From: Brenda Bernot <BBernot@wegopd.org>
Sent: Friday, June 16, 2023 4:58 PM
To: Mila Carter <lcarter@westtown.org>
Subject: RE: Fox Clearing, LLC - "Stokes Estate" Conditional Use Application - Reviews and PC meeting 6/21

RE: Conditional Use Application, Fox Clearing, LLC: Stokes Estate

Re: Stokes Estate (Fox Clearing, LLC)
Conditional Use - Traffic Review
Westtown Township, Chester County

RE: Stokes Estate
Conditional Use Review
Westtown Township
WTT-21-228

Length as Total Volume

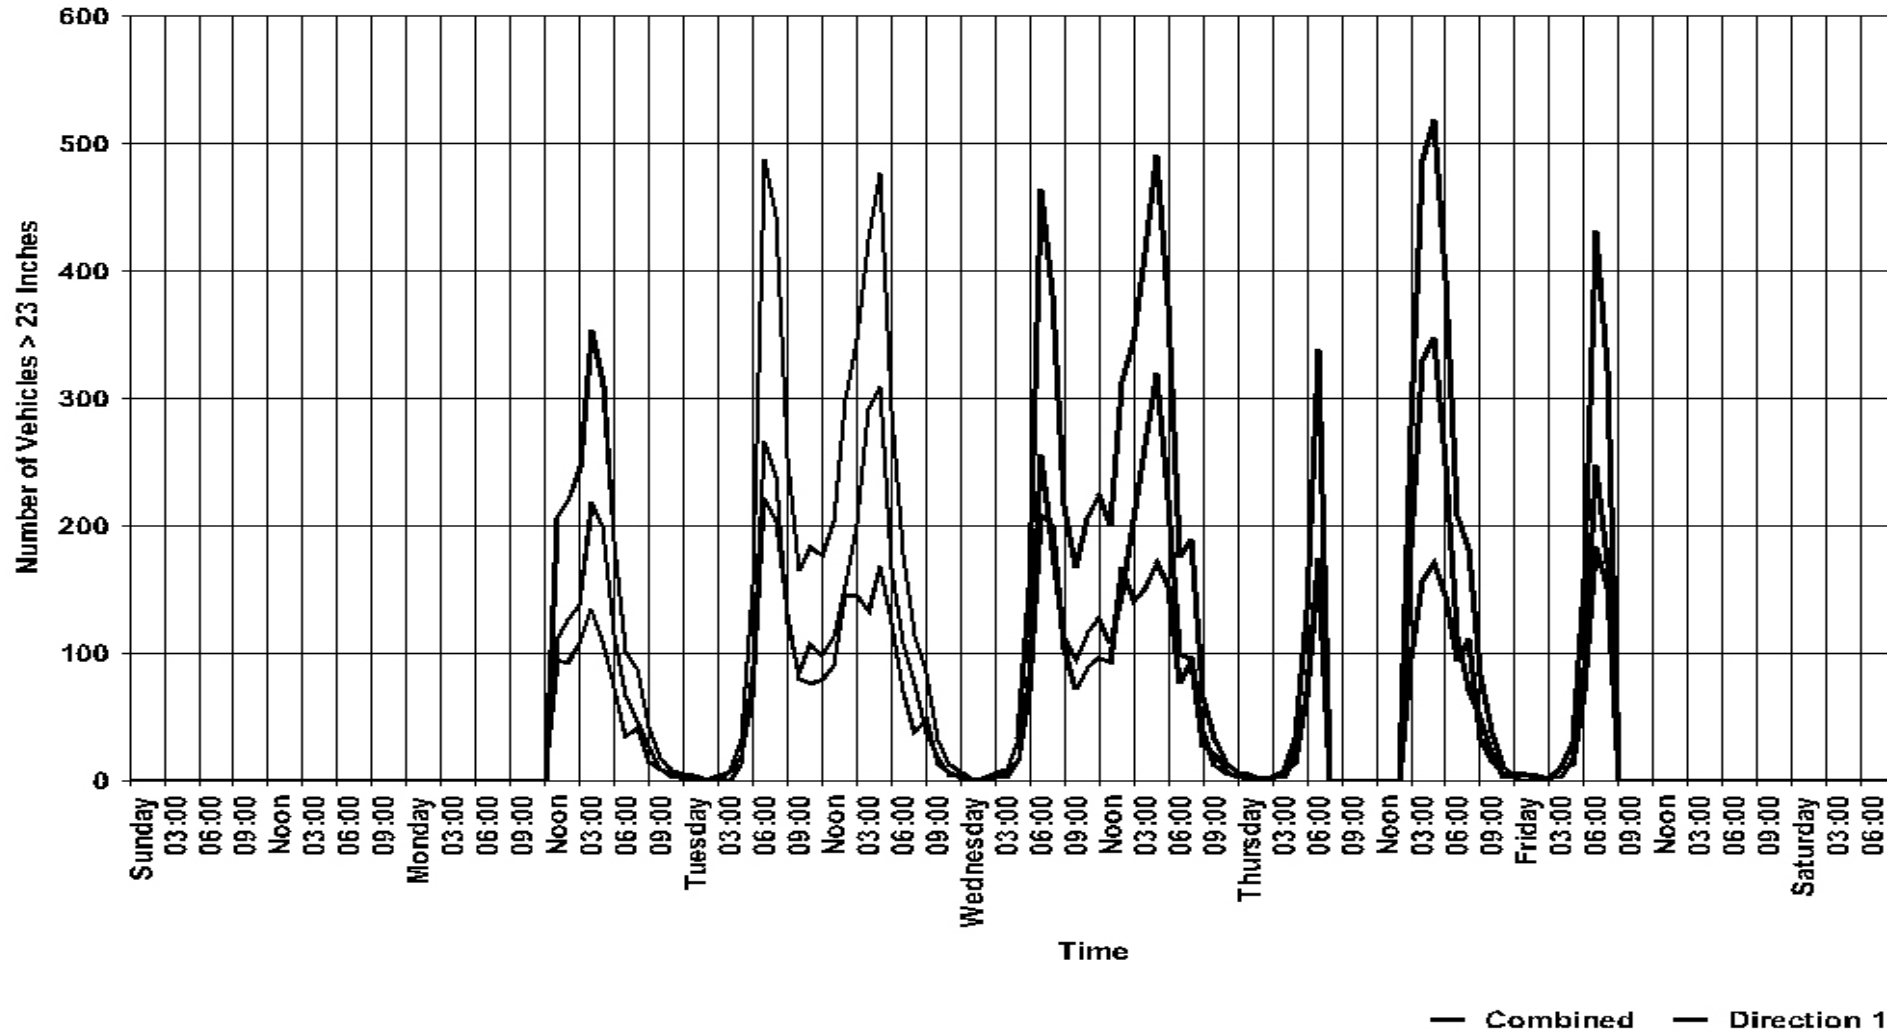
3. Although the data from the traffic study (2 attached files) is a little dated (from 2020), it clearly shows that 85th percentile for speed on Shiloh Road is between 43 and 44 mph (in a posted 30 mph zone). Additionally, the study indicated that there were a notable number of vehicles traveling between 51 and 60 mph, as well as a few vehicles traveling 61 mph or higher. Please have your traffic engineer review this data thoroughly, as we feel that speed is already an issue on this roadway. As a result, we conduct traffic enforcement on the roadway on a fairly consistent basis. If requested, we would be happy to conduct an updated traffic study on this roadway but we assume that your engineer may want to conduct their own.
